CITY OF ALBUQUERQUE

RE: 10800 Gibson SE (SSTP)
Grading and Drainage Plan

Engineer's Stamp Date: 7/18/17 Hydrology File: M21D007A1

SHEET TITLE **GRADING &** DRAINAGE PLAN

ONSITE DRAINAGE RETENTION

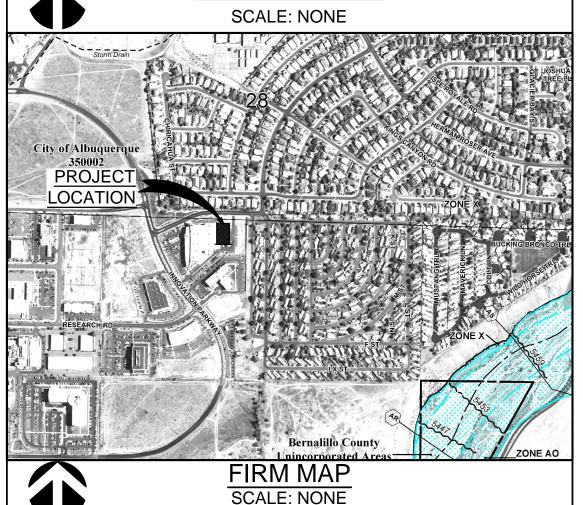
1. First flush volume needs to be determined from: (0.44"-0.10") x impervious area. The determination from 0.43" x impervious area over-estimates the required ponding volume.

- 1. Drainage Plan and Narrative has been updated to show compliance with previous drainage reports and master plan. See updated narrative.
- 2. First flush calculations and pond volume has been updated to reflect calculation of (0.44"-0.10"). Additional runoff for 100yr, 10 day volume has not been included in the new ponding area.

FIRST FLUSH STORAGE REQUIRED BY COA HYDROLOGY:

PROVIDE STORAGE FOR FIRST FLUSH RUNOFF PER SECTION 22 OF DPM TABLE A-6 USE 0.44 - 0.1 = 0.43 IN

FIRST FLUSH (IN) APPLIED OVER IMPERVIOUS AREAS (ACRES) THEREFORE 0.43/12 X 0.47 X 43560 = 733 CF

FIRST FLUSH PONDING AREA REQD. = 733 CF < 880 CF PROVIDED
